Product Change Notification: MFOL-25TRW0648

CCB 7231.013 Initial Notice: Qualification of MMT as a new final test site for ATMEGA644-20PU, ATMEGA644P-20PU, ATMEGA32-16PU, ATMEGA8515-16PU, ATMEGA162-16PU, ATMEGA8535-16PU, ATMEGA8535L-8PU, AT89S8253-24PU, AT89C51RC-24PU, and AT89C55WD-24PU catalog part numbers (CPN) available in 40L PDIP (.600in) package.

PCN Status: Initial Notification

PCN Type: Manufacturing Change

CCB 7231.013
Pre and Post Change Summary
PCN #: MFOL-25TRWO648

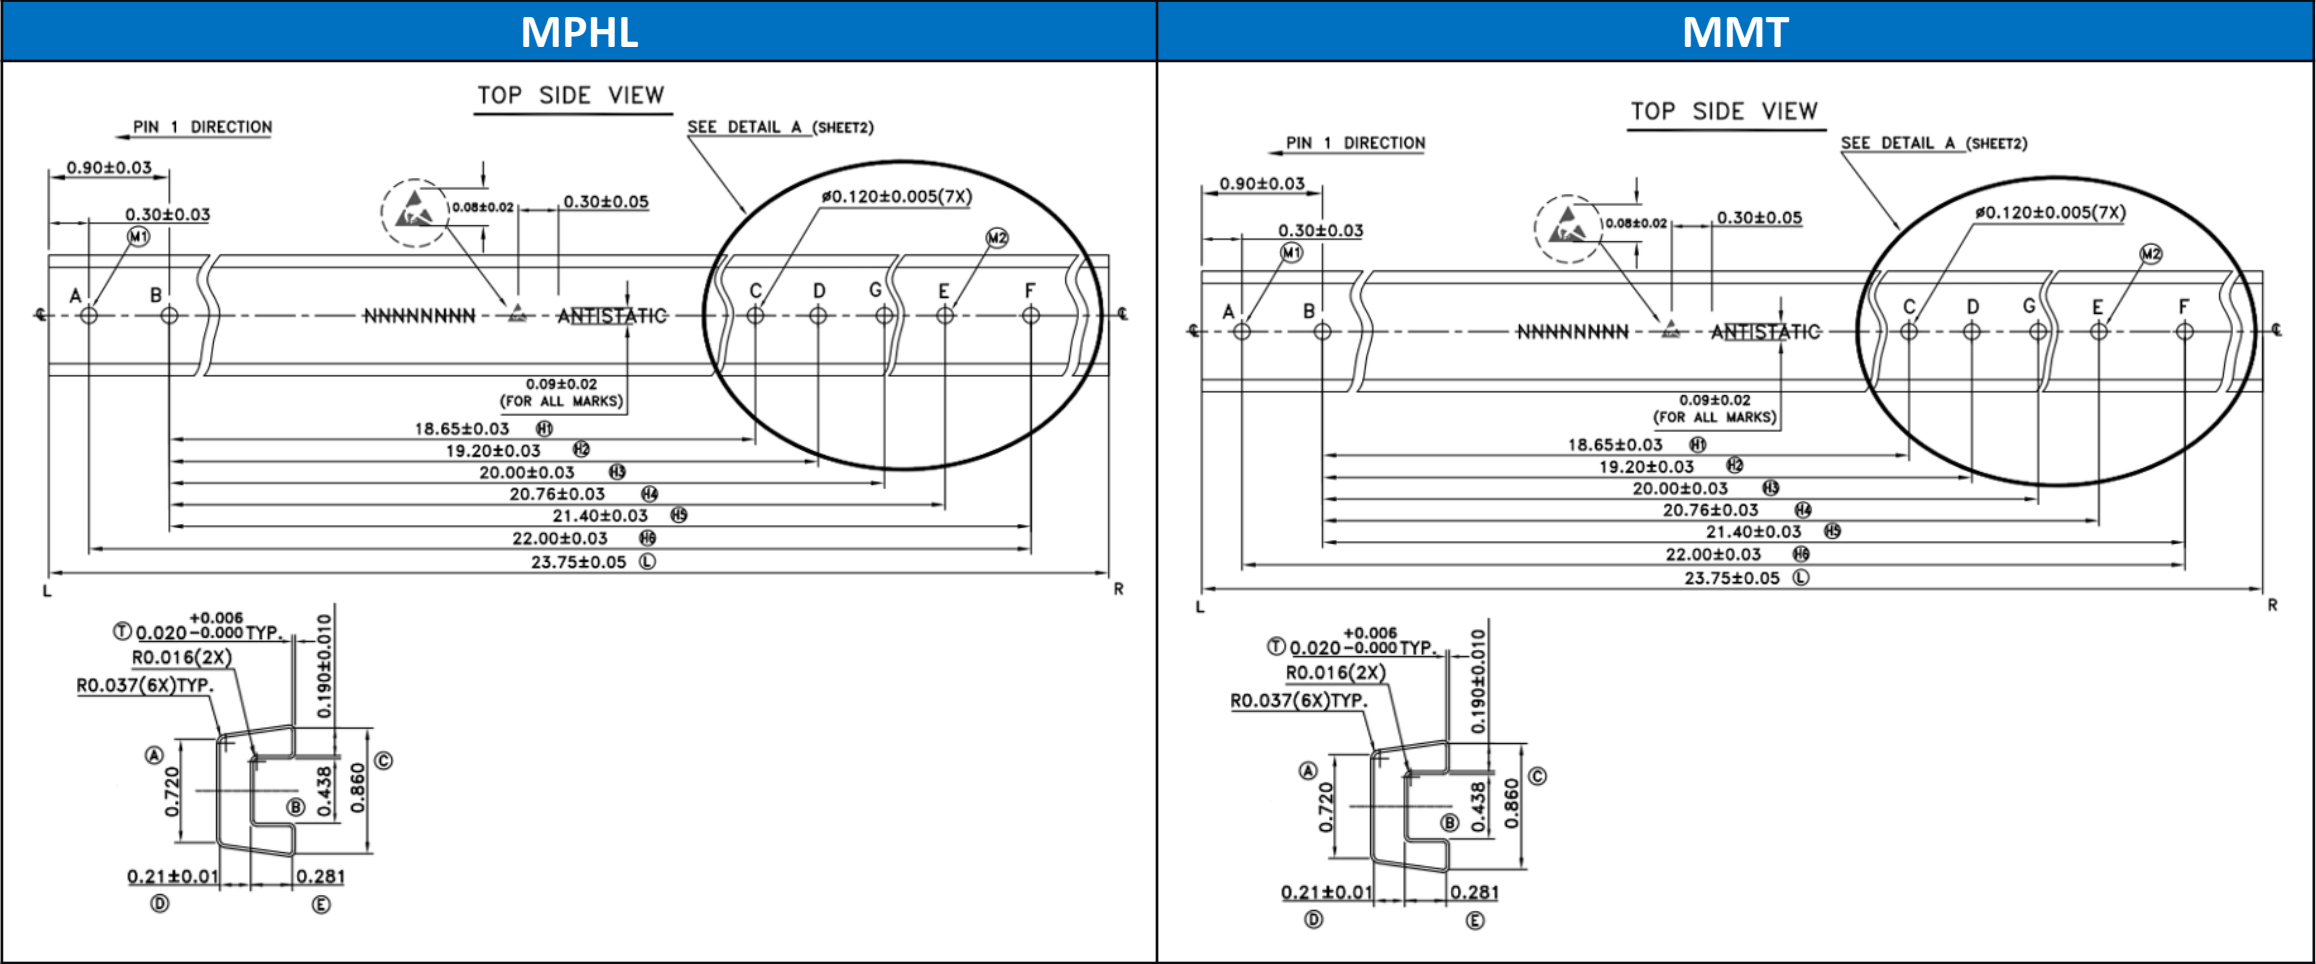
Pre Change	Post Change
Final Test Site	Microchip Technology Operations (Philippines) Corporation (MPHL)	Microchip Technology Thailand (Branch) (MMT)

Pre and Post Change Summary - Tube

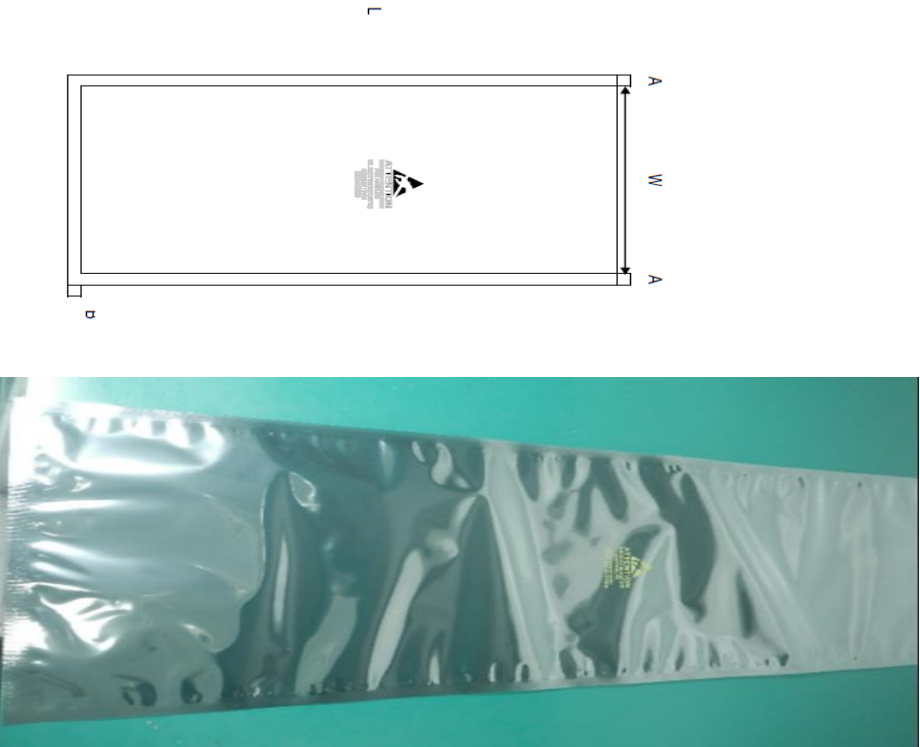
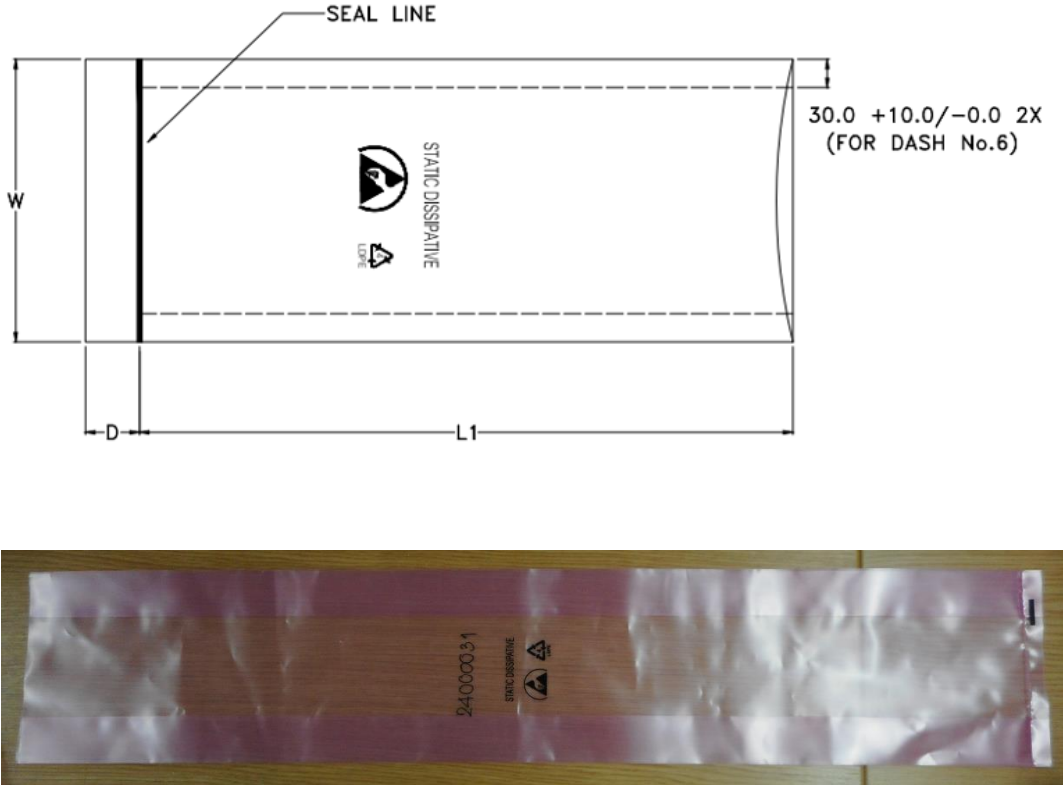
Location	Tube Length (inch)	Unit per Tube	Tube per Bag	Tube Color
MPHL	23.75 +/- 0.05	10	24	Transparent Clear
MMT	23.75 +/- 0.05	10	24	Transparent Clear
